Applicant:	Boisclair Corporation
Location:	10041 Penn Avenue South
Request	Major Revision to Preliminary and Final Development Plans to construct a four-story, 68-unit apartment building.
Existing Land Use and Zoning:	Multiple-family residential; zoned RM-24 (PD), Multi-family residential (Planned Development)
Surrounding Land Use and Zoning:	North – Senior independent/assisted living; zoned RM-24(PD) East – Office; zoned B-1 South – Place of Assembly Parking and railroad; zoned R-1 West – Single and Multiple-family residential; zoned R-4
Comprehensive Plan Designation:	High Density Residential

In Case #PL2020-68, having been able to make the required findings, I move to approve a Major Revision to Preliminary and Final Development Plans to construct a four-story, 68-unit apartment building at 10041 Penn Avenue, subject to the conditions and Code requirements attached to the staff report.

Project Description: Major Revision to Preliminary and Final Development Plans to revise a previously approved but not yet constructed four-story, 43-unit apartment building (Case #PL2018-167) by expanding the building footprint and increasing the unit count to 68 total units.

Figure 2: Additional storage options within the garage.

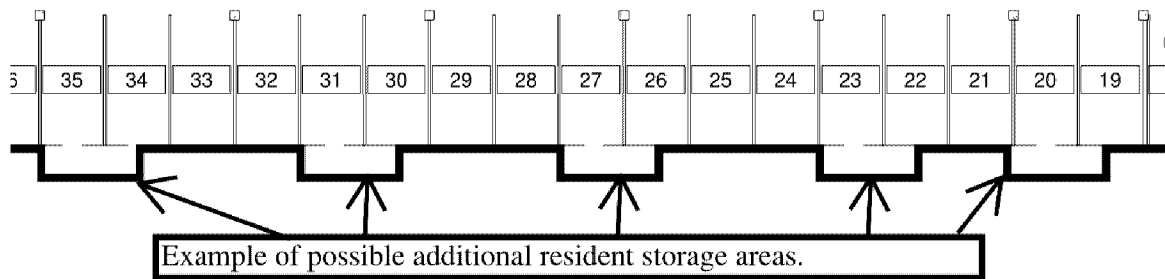
- **Storage Space Reduction** – The OHO allows a reduction in the required number of storage spaces outside the dwelling unit by fifty percent (50%) provided that the affordable housing agreement pursuant to Section 9.32 provides that the owner will not charge the opportunity housing units for access to storage space. The applicant is proposing 34 Code complying storage units on the first floor. While this flexibility is allowed, the applicant has areas in the garage that could provide additional storage units. While additional storage is not required, staff believes increasing the storage available would enhance the livability of the units and should be considered. See Figure 2 for areas to increase storage opportunity, which would provide low cost additional storage if the parking were assigned and the storage assigned to the adjacent parking space tenant.
